SERVICE CAMPAIGN BULLETIN

CAMPAIGN REF: 01H
TITLE : HVAC Drain tube modification
DOCUMENT # : 11 A 030

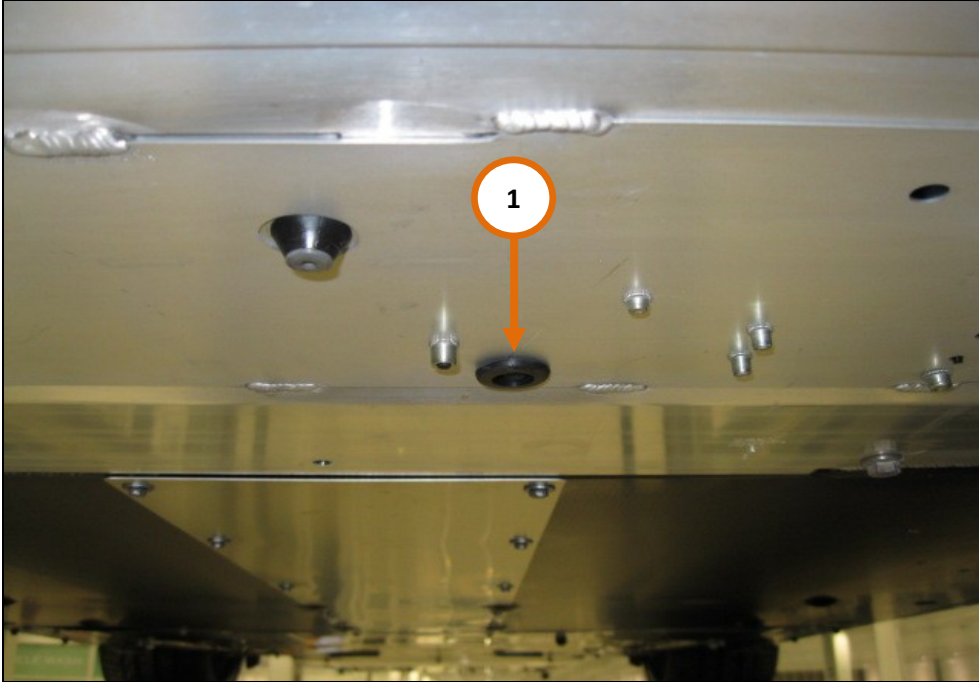
1. Locate the HVAC drain tube in the front subframe (1).

Care Point: It is not necessary to remove the drain tube to perform the modification.

2. Remove the valve from the drain tube using a pair of long nose pliers (2).

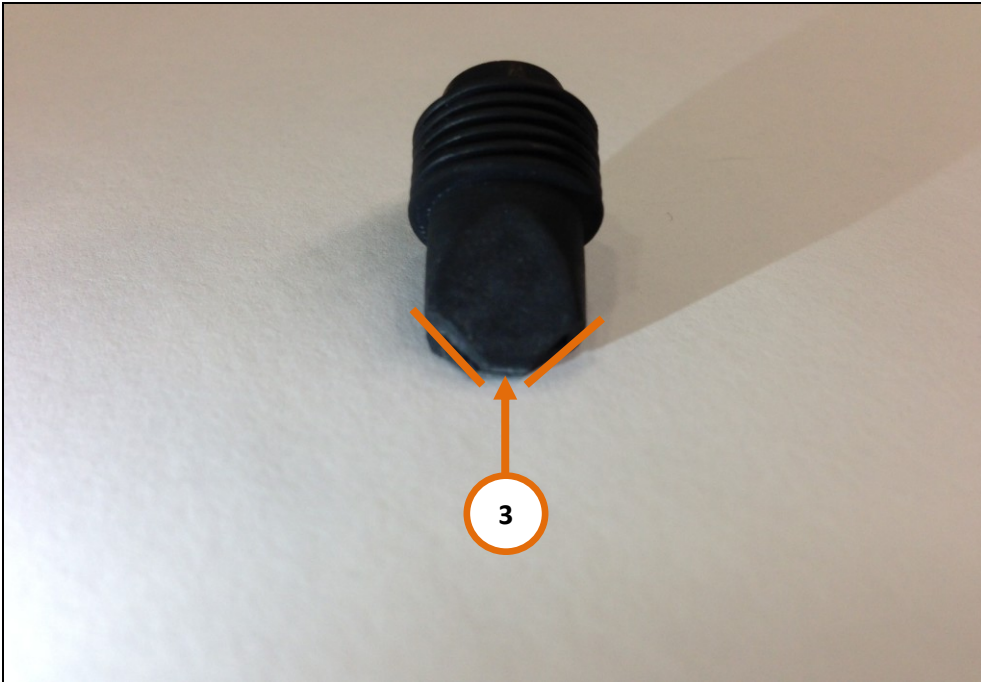
3. Cut the two edges (3) to create a constant drain path.

4. Reinstall the valve into the drain tube (4), ensuring that it is correctly located (5).
